Town of Arlington, MA Redevelopment Board

Agenda & Meeting Notice December 1, 2025

2. Public Hearing: Docket #3869, 9-11 Robbins Rd (continued from November 10, 2025)

To: Arlington Redevelopment Board
From: Claire V. Ricker, AICP Secretary Ex-Officio
Subject: Site Plan Review, 126 Broadway, Docket #3867
Date: November 25, 2025

PROPOSED SITE PLAN

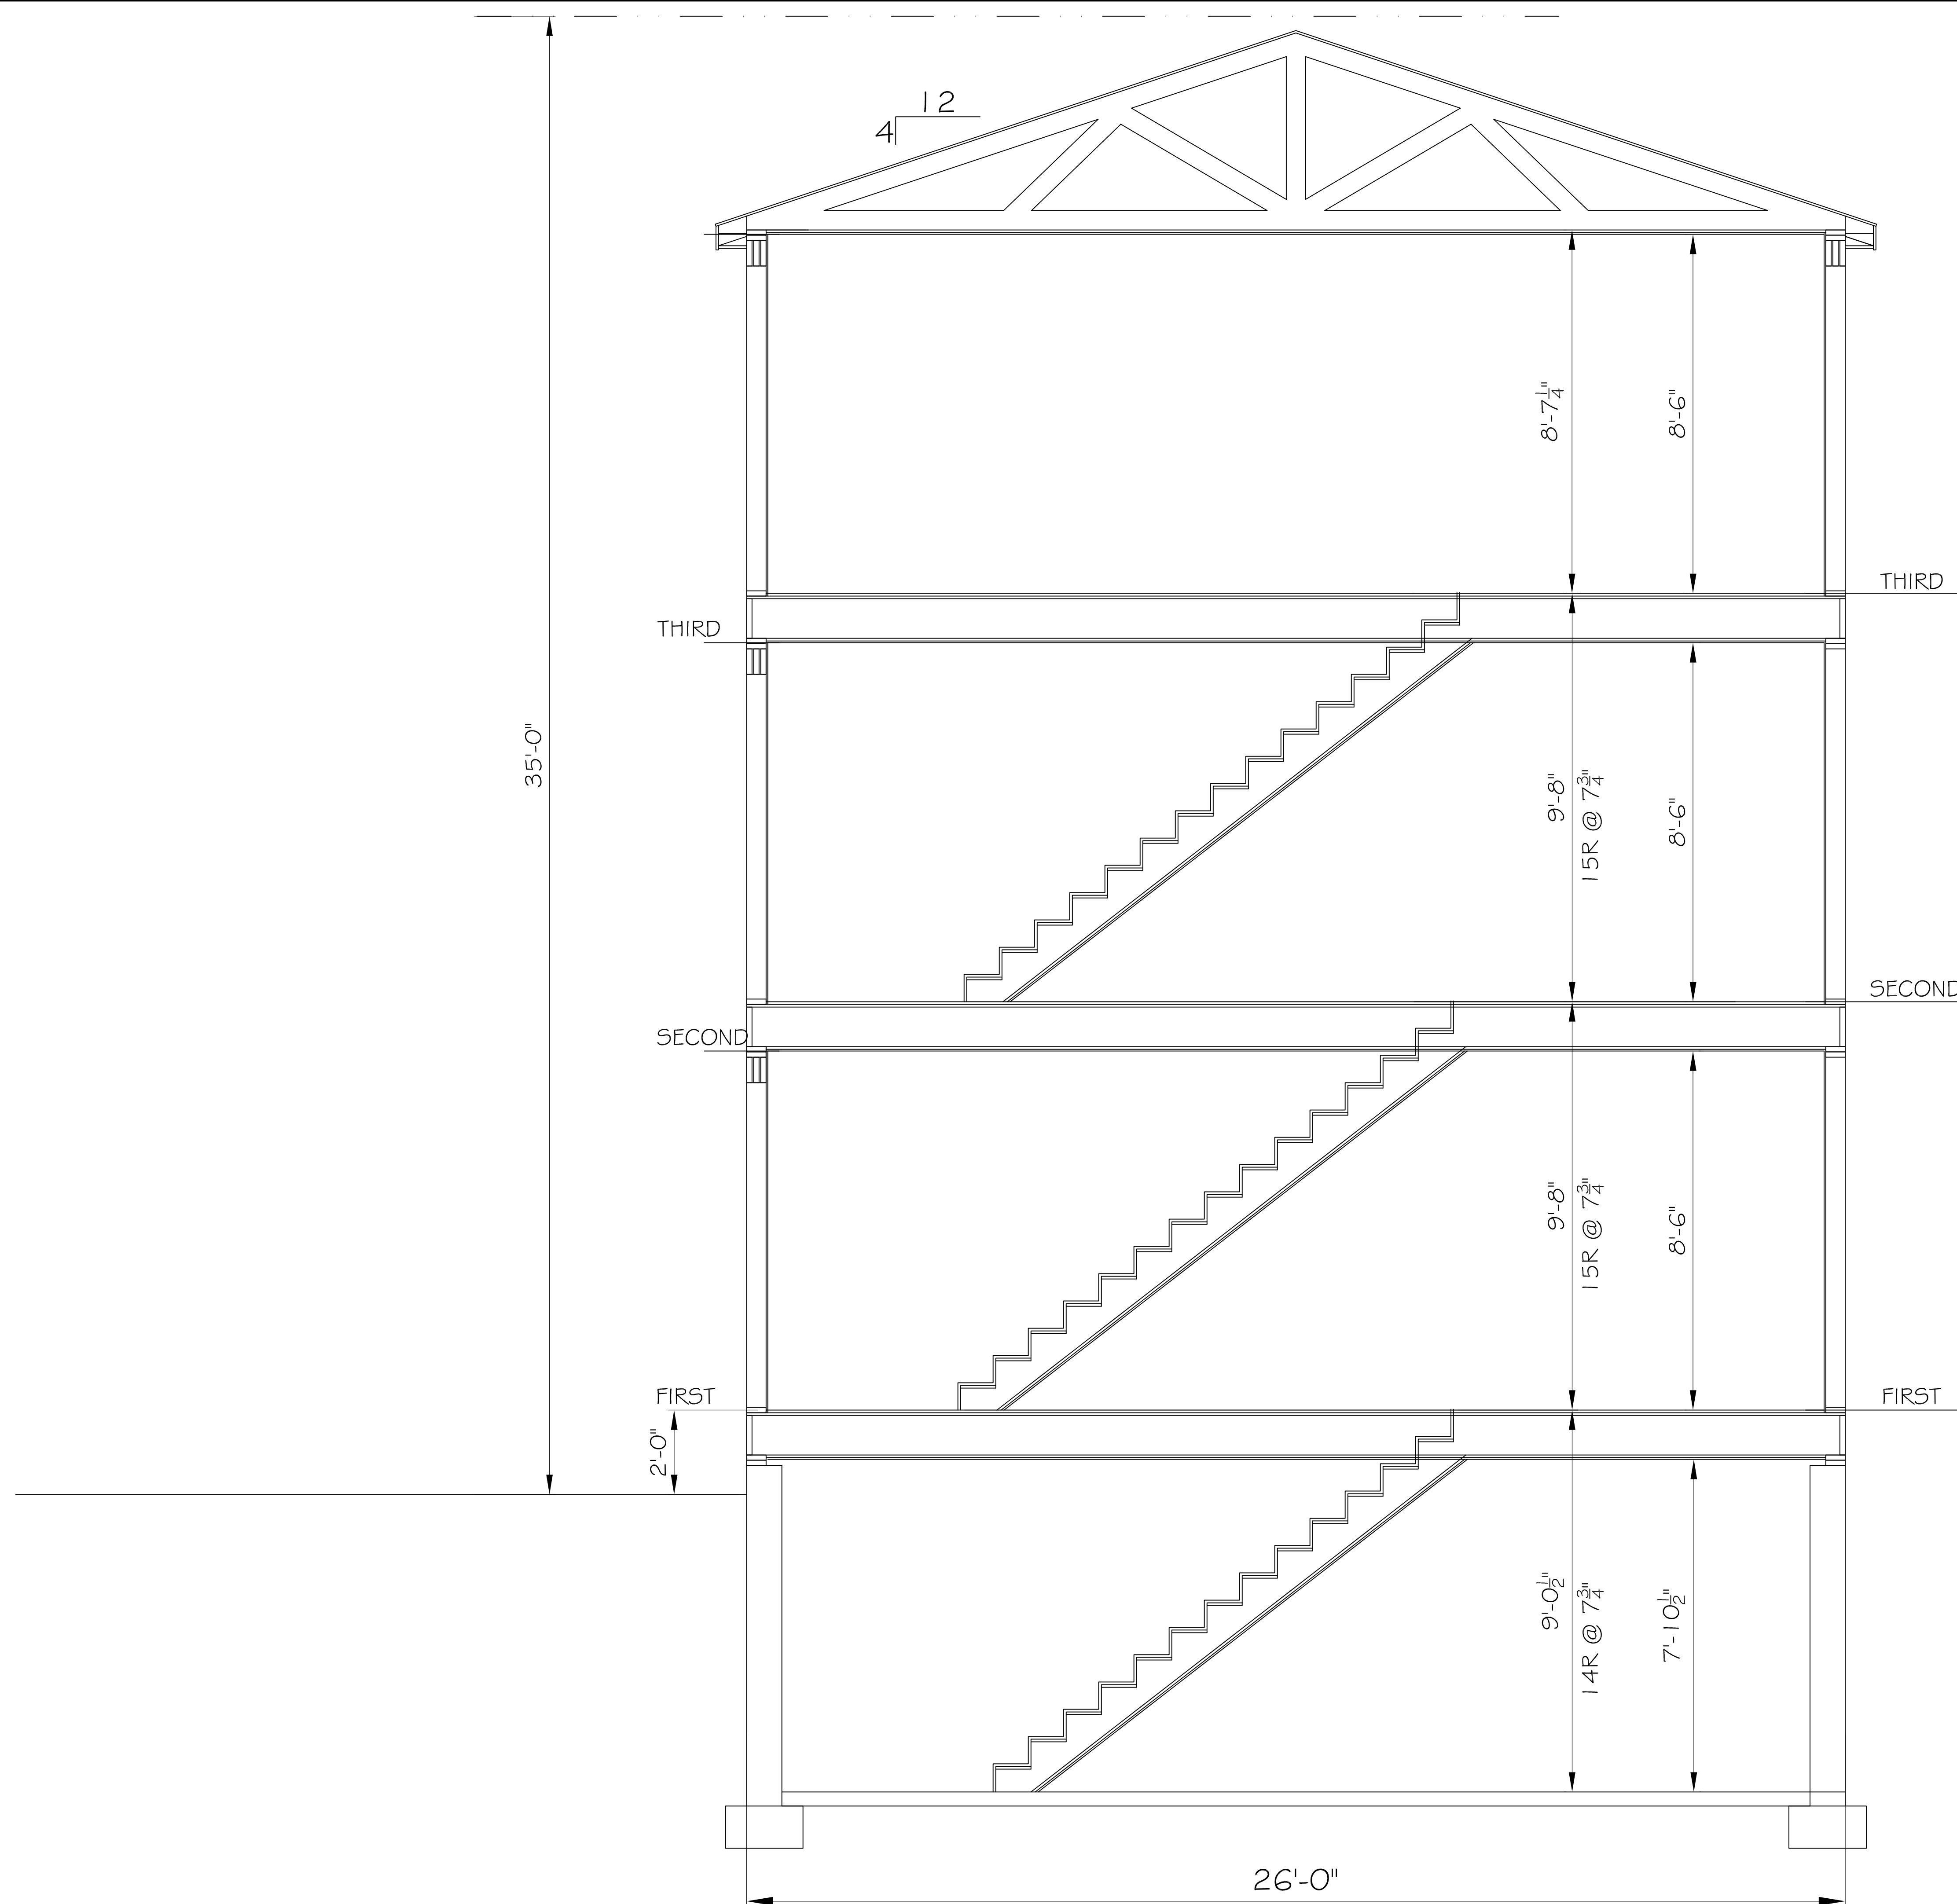
Landscaped open space is proposed for the front yards on this corner lot. The front setback will be enhanced with plantings and walkways. The rear and side yards will include additional lawn areas and a common space with side porch entries and stone pavers in between the two buildings. Each of the units also has a balcony on the third floor. The applicant should clarify if any fencing is proposed along the rear and side property lines.

The proposed site plan shows eight (8) trash and recycling receptacles and a condenser for each unit located in the common area between the buildings.

Equipment for heating and cooling will be located in the common area between the buildings. The roof plan includes an area designated for a solar array. A solar array assessment was not submitted. No other mechanical equipment is shown on the site plan.

This applicant has completed a LEED checklist. The applicant should clarify whether two or four parking spaces will have access to an EV charger. The development will comply with the Town's Specialized Stretch Energy Code and the Fossil Fuel-Free Bylaw which ensure a maximum level of energy efficiency is achieved.

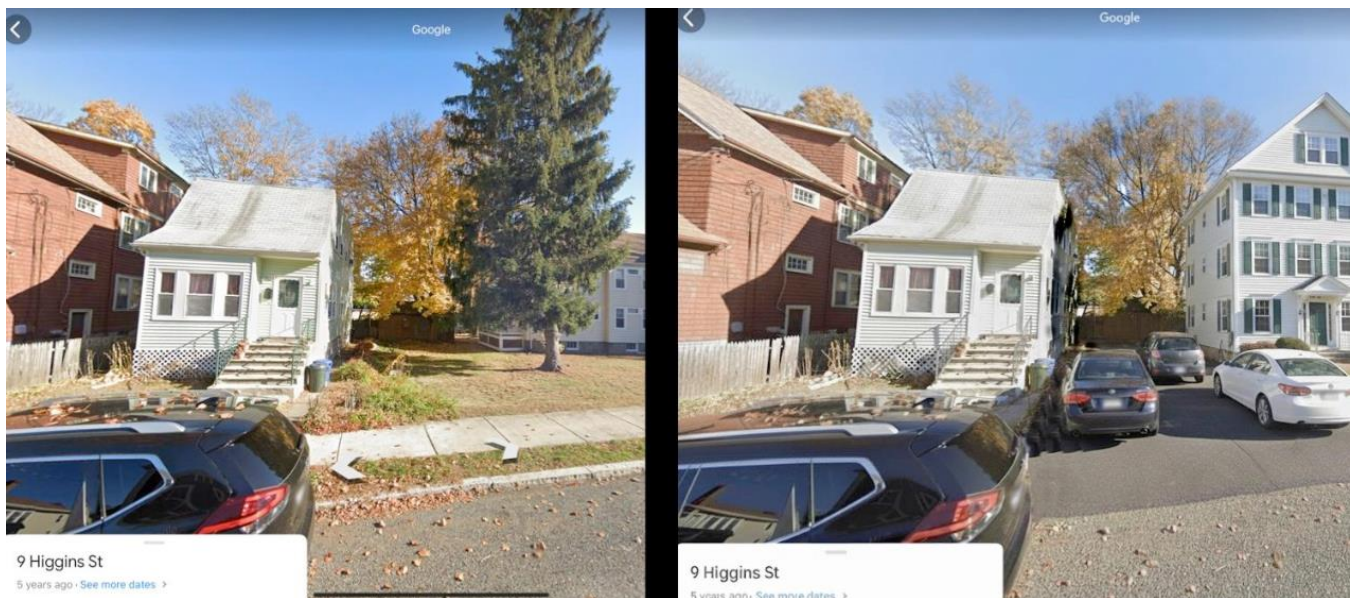
Also per our law, parking areas must include at least 5 feet of on-site screening or fencing to buffer abutting residential lots. This would be impossible if the driveway/pavement is allowed as requested.

I am including a 'before'/'after' picture.
